Determination 2023/027

The pathway to demonstrate compliance with clause E2 of a proposed direct-fixed plywood cladding system on a building at 13 Pendene Place, Forrest Hill, Auckland

Summary

Figure 2. The north-east elevation

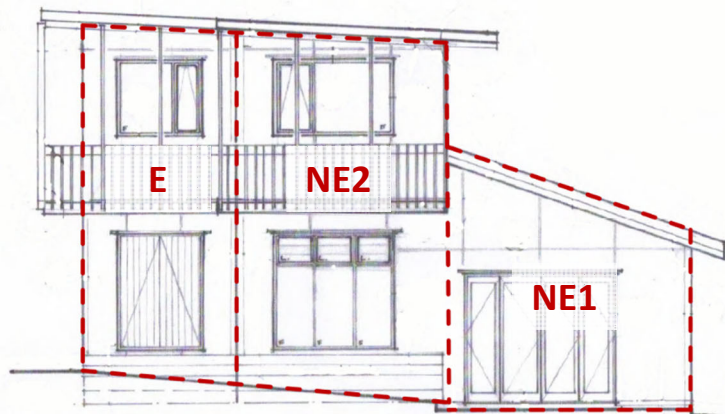
- 4.29. For the owner's workshop addition, there are two aspects of the decks that are in dispute: the first-floor folly balcony on the north-east and south-east elevations of the building, and the first-floor deck to the south-west of the building that connects to the existing deck and residential dwelling.

- 4.30. I note that while the first-floor folly balcony does not allow for pedestrian access, its construction is still similar to a cantilevered balcony. Accordingly, I am assessing the projection as a deck. The soffit to the underside of this projection is composed of 80mm-wide timber boards, with 5mm gaps to provide ventilation and drainage. The designer submits that these ventilation gaps mean the “bottom side linings are not sealed”. While I agree with the designer that the ventilation gaps will assist in drying and draining the projection’s substrate and structure, I am of the view that they still enclose the underside of the projection. There are still risks associated with moisture ingress and accumulation, and difficulties in detecting any potential damage in any areas hidden by the lining.

- 4.32. Therefore, there are high-risk deck elements present on the following wall faces: NE2, E, SE1, SE2, and SW3.
- 4.33. While wall faces NE2, E, and SE1 are two storeys in height they have been assessed as having a low risk with regard to the number of storeys. The Ministry’s guidance¹³ notes that a higher number of storeys means more water will be caught and run over vulnerable junctions on lower levels. However, these wall faces are horizontally split by the folly balcony at the first-floor level. Any water caught by the cladding on the first-floor level is diverted away from the cladding on the ground floor. Therefore, the cladding is functionally one storey in height and a low risk.

Figure 3. The south-east elevation

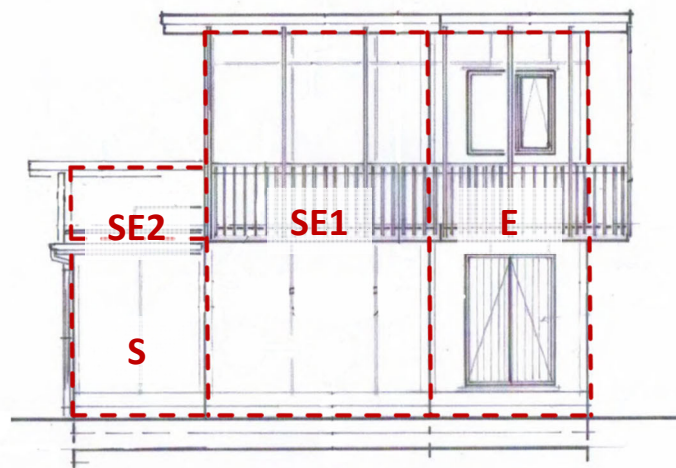
- 4.26. The design for the workshop addition includes multiple level roofs intersecting with the external walls at several different levels. These types of very high-risk junctions are seen on wall faces SE2, SW3, and NW2.

Figure 4. The south-west elevation

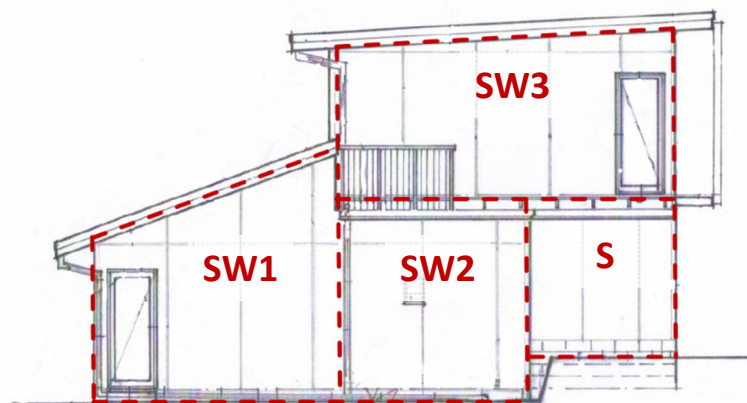
- 4.31. The first-floor deck to the south-west of the building consists of a removeable slat and joist timber frame sitting over a waterproof membrane deck structure. This deck is situated over the stairwell and hot water cupboard on the ground floor of the building. The deck is enclosed to the underside, with internal ceiling linings supporting internal insulation. The designer submits that the presence of cavity closer vents, located at the verge of the deck, means the deck is not enclosed. I do not agree. While the vents may aid in ventilating the decking substrate, the deck is still enclosed to the underside, and in my view comes within the definition of an enclosed deck.
